**ADDENDUM NUMBER 4 ON INVITATION TO BID ITB20KO-136**

**TITLE:** IFAS Demonstration Pavilion – Live Oak, FL

**Responses to Contractor Questions and Requests for Clarification**

**SHEET**  
**A4.0**  
PROPOSED -  
SECTIONS -  
BUILDING  
1460-30

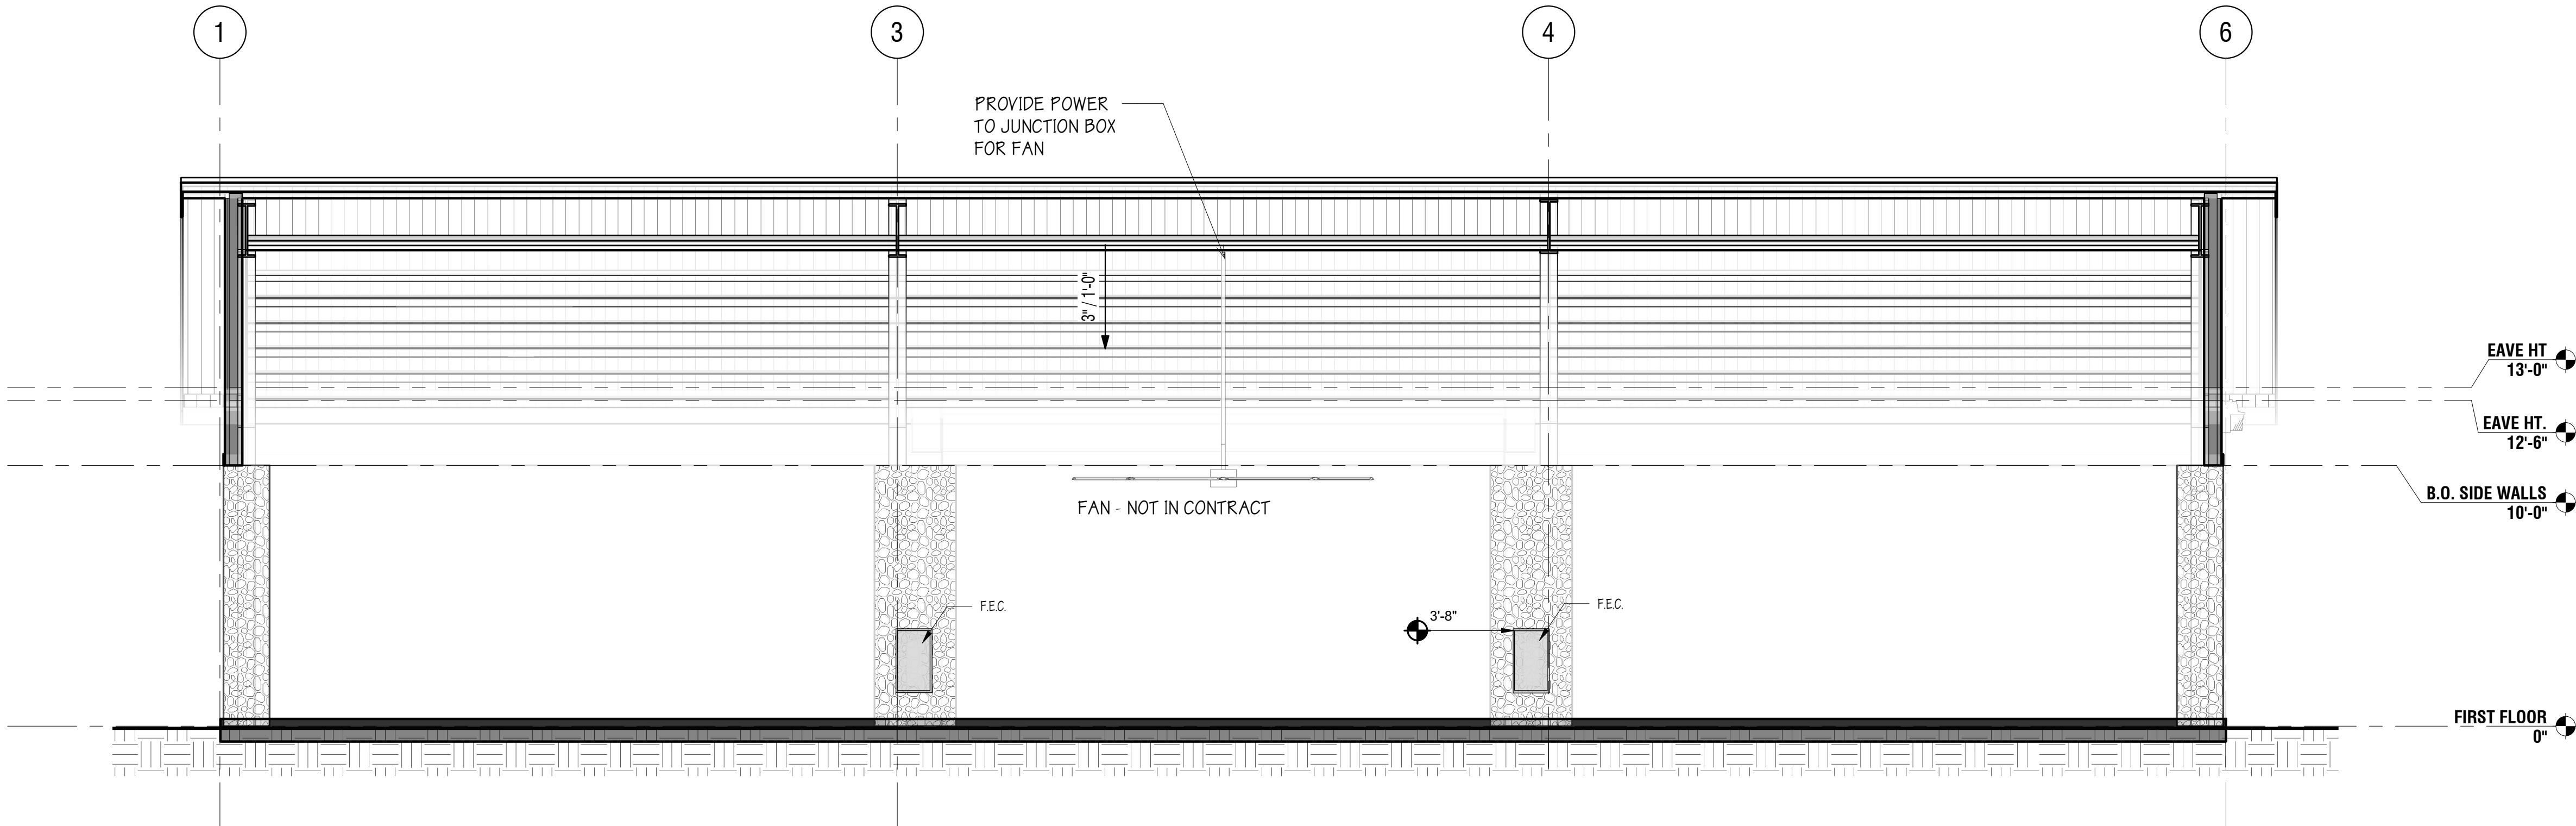
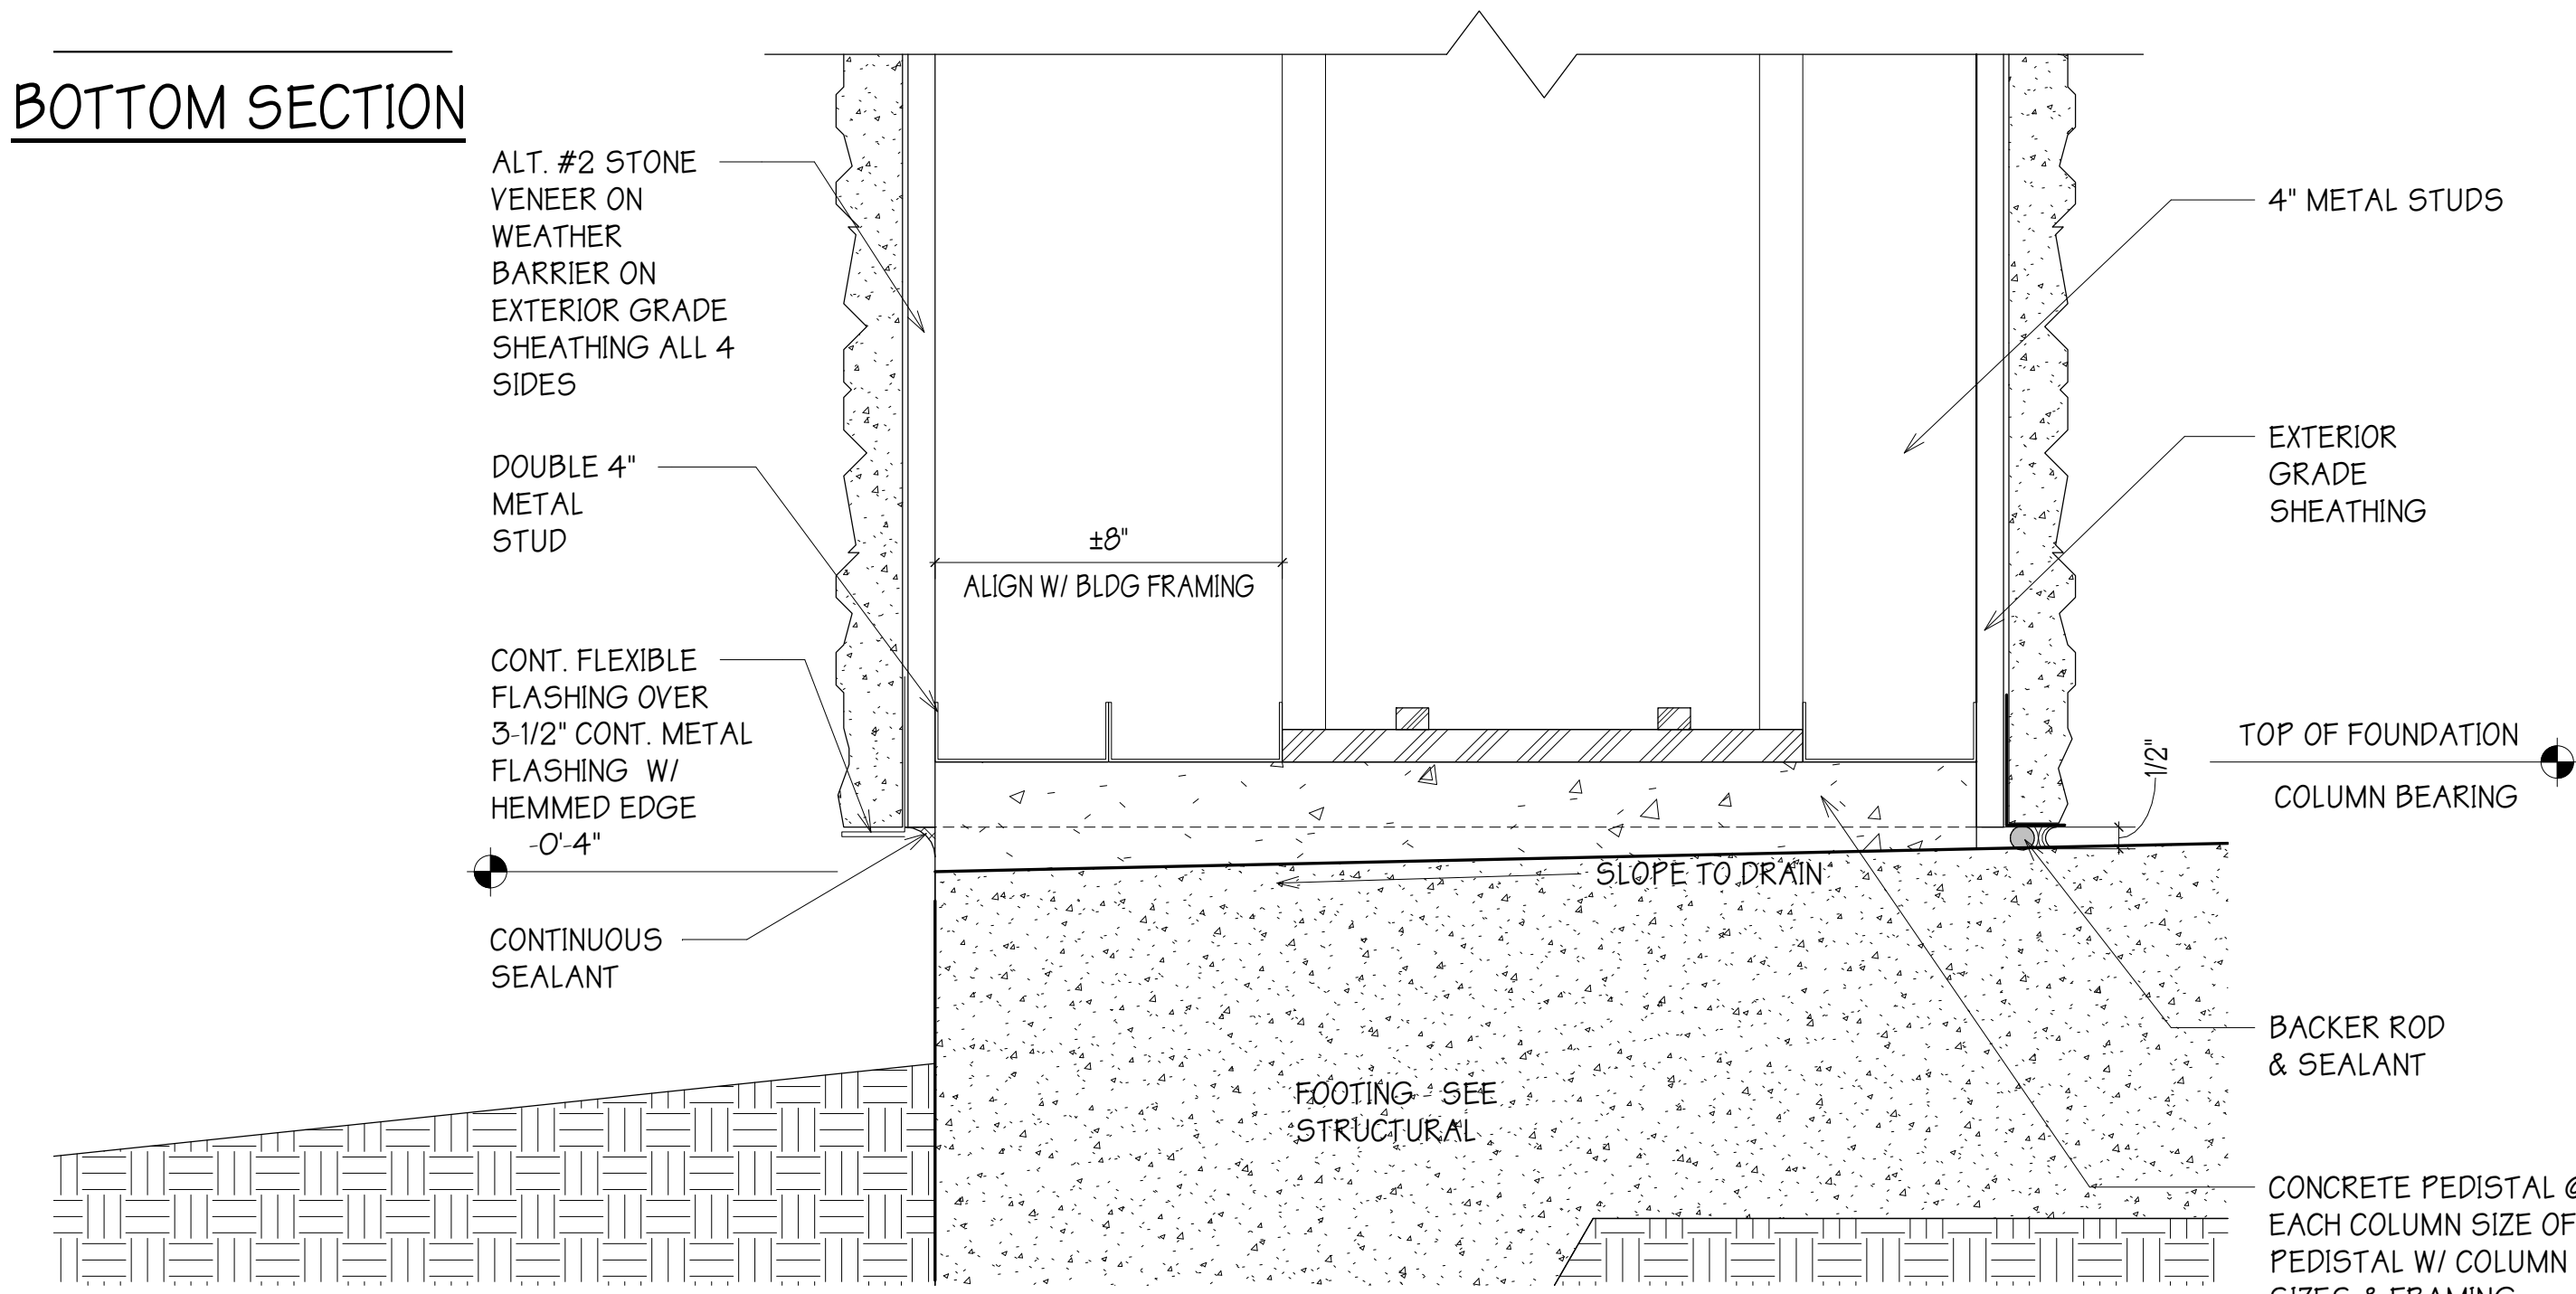
Q6. Specification Section 16305 ceiling fans is not on the table of contents, but the specification is in the spec book. On drawing A4.0 it states "Fans" not in contract. Please clarify this scope of work.

A6. The Owner will furnish and install the specified ceiling fan. The contractor is responsible for the electrical serving the fan and fan junction box suitable for the specified fan.
